# REGIONAL REVIEW NOTICE

**ARC REVIEW CODE:** R1706301

**Name of Proposal:** Horizon Pointe 400 (DRI 2688)

**2688 HORIZON POINTE 400 DRI**  
**Gwinnett County**  
**Natural Resources Group - Review Comments**  
**June 28, 2017**

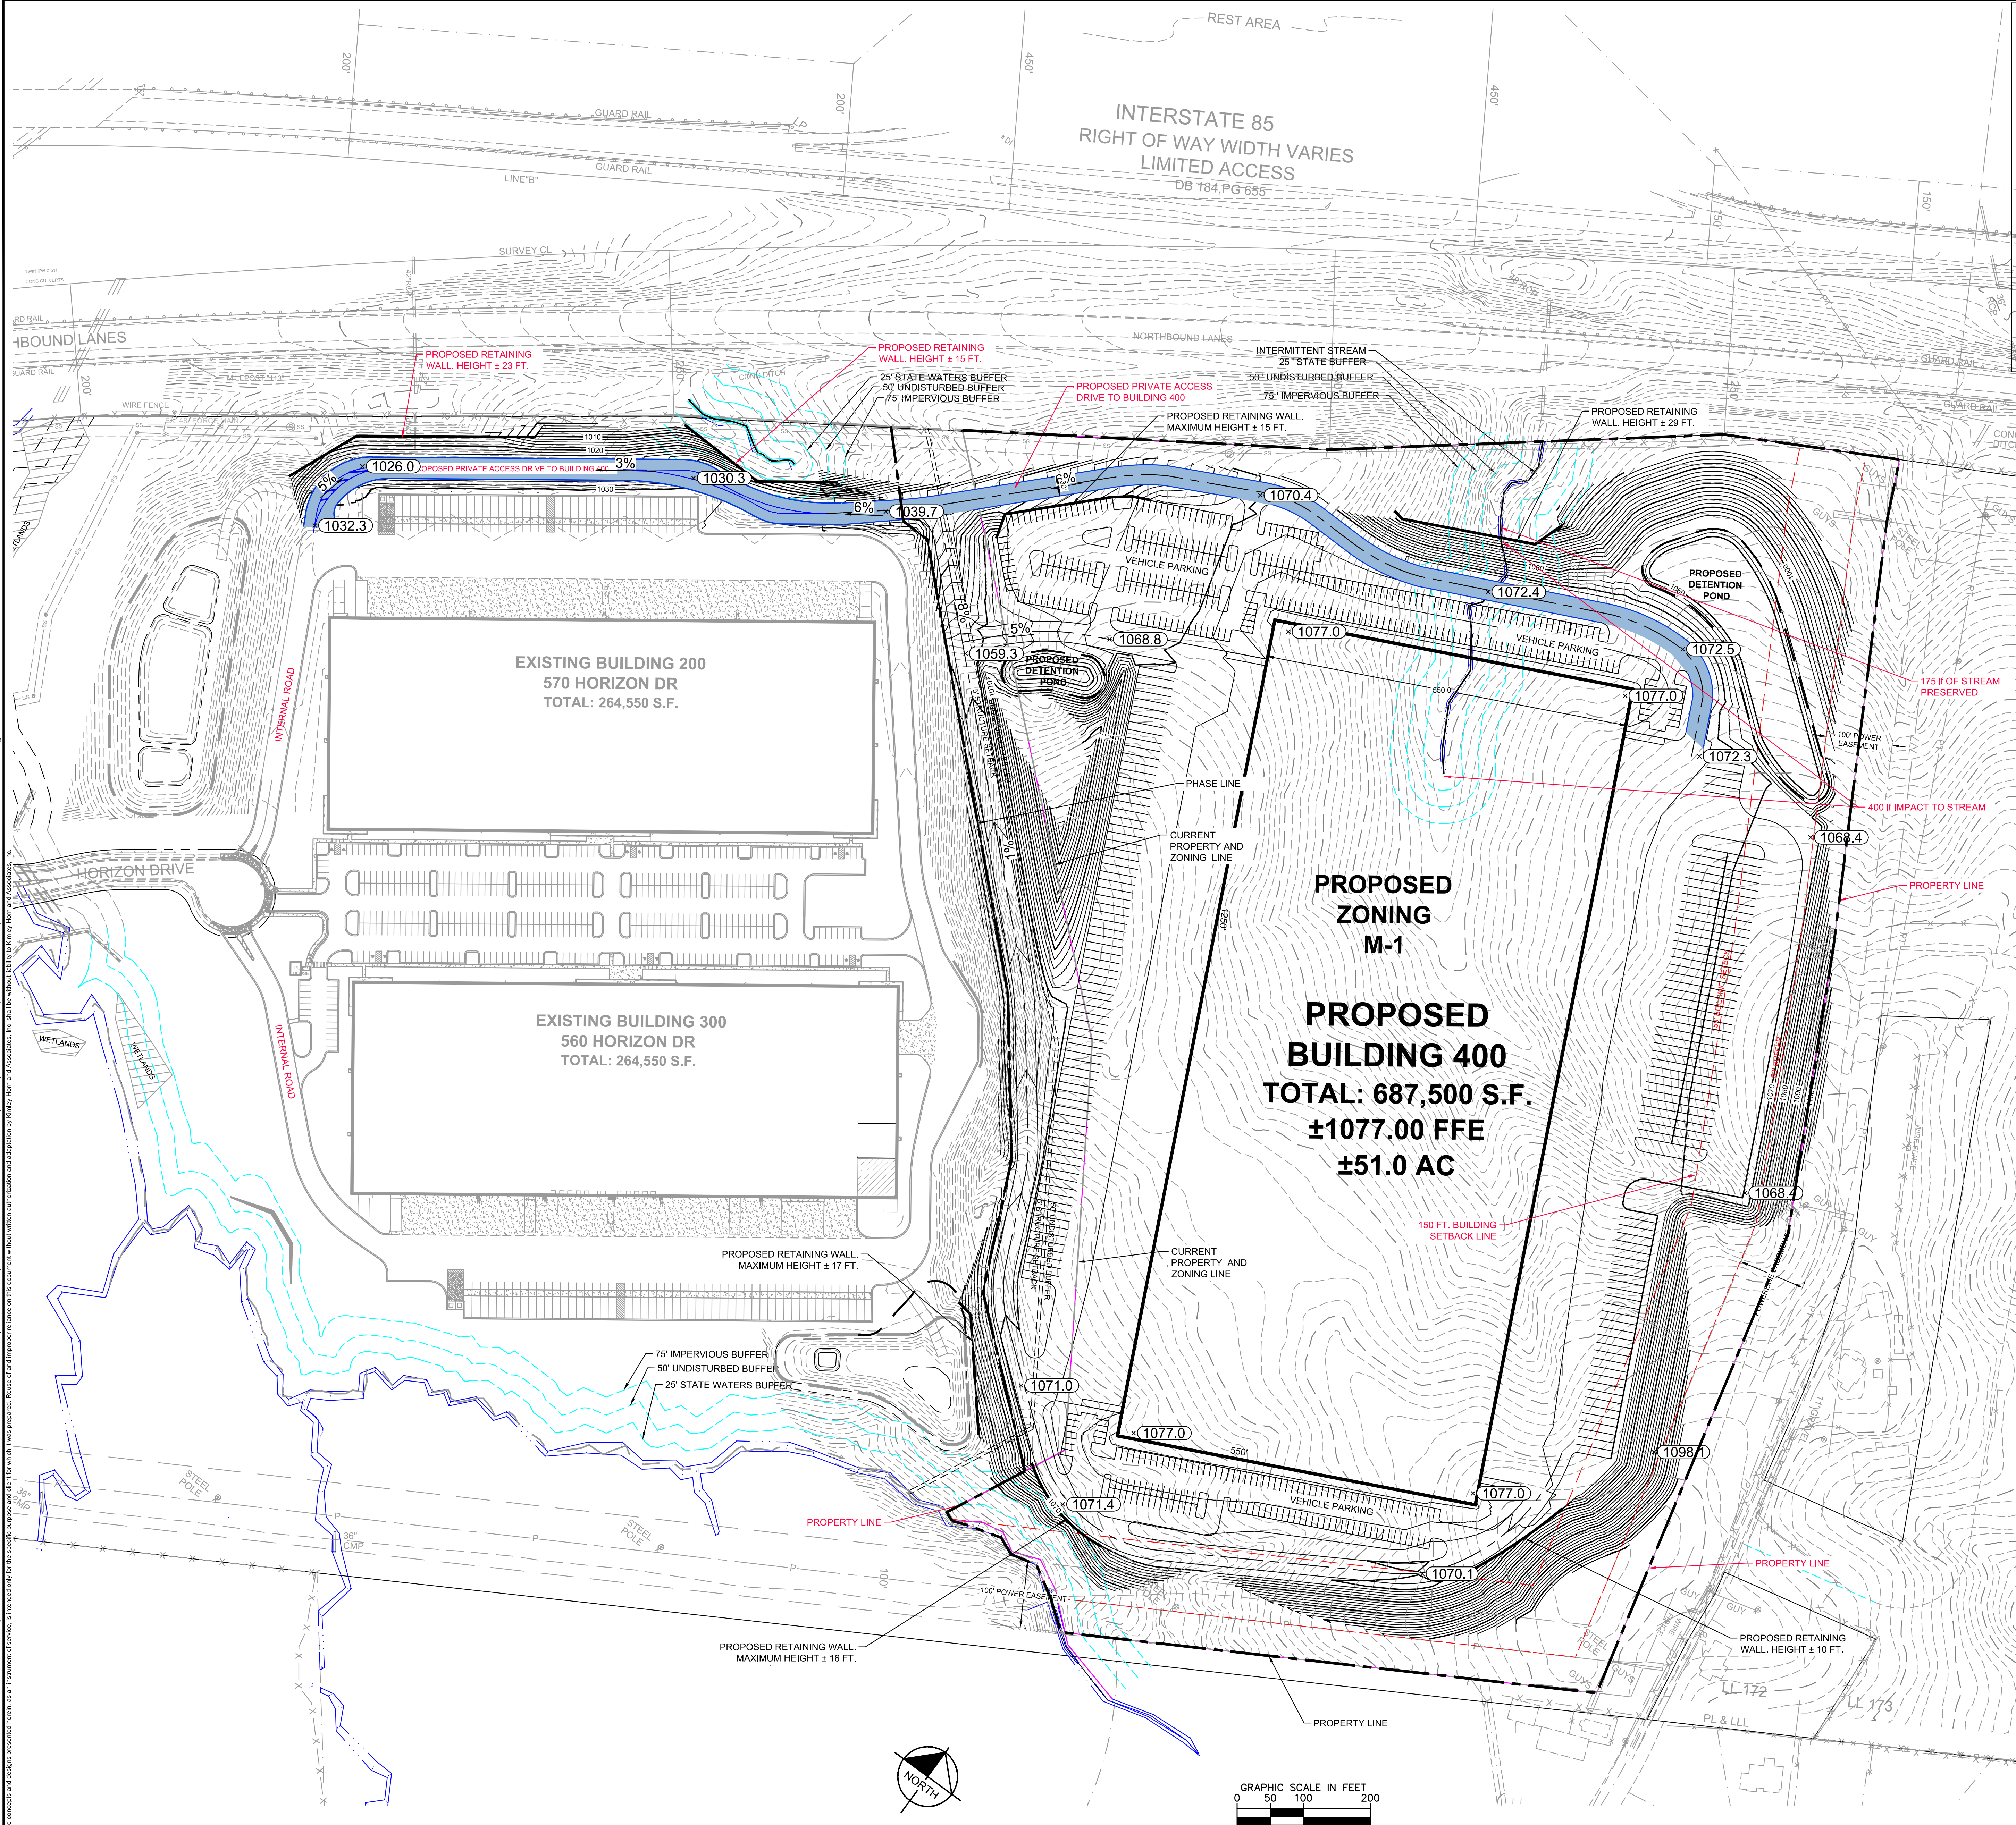
The USGS coverage for the project area shows blue line streams to the east and west of the project property. The submitted site plan shows the headwaters of two streams at the northern edge of the project property, as well as a stream at its southwestern corner. All these streams are tributaries to Ivy Creek, a tributary of Brushy Creek, which flows into the Chattahoochee River. The State Erosion and Sedimentation Control buffer as well as the County's 50-foot stream buffer and additional 25-foot impervious setback are shown and are clearly labelled on all streams shown on the property. The proposed plans show buildings and parking over one of the streams, as well as grading intruding into the other stream buffers. These and any other intrusions into County buffer or setback may require a variance, as will intrusions into the state 25-foot Erosion and Sedimentation buffer. Any unmapped streams on the property may also be subject to the requirements of the County stream buffer ordinance. Any unmapped state waters on the property will also be subject to the State 25-foot Erosion and Sedimentation buffer requirement. .

The development consists of single warehouse building with adjacent warehouse uses to the west of the site. The site plan does not depict inter parcel connectivity for vehicle or truck access being provided. There is a change in grade between the two developments that may make reasonable connectivity a challenge.

Internal sidewalks are depicted on the site; the site plan does not show walkways being provided. The site plan also shows that vehicular traffic is separated from freight traffic by separate internal driveways and parking facilities.
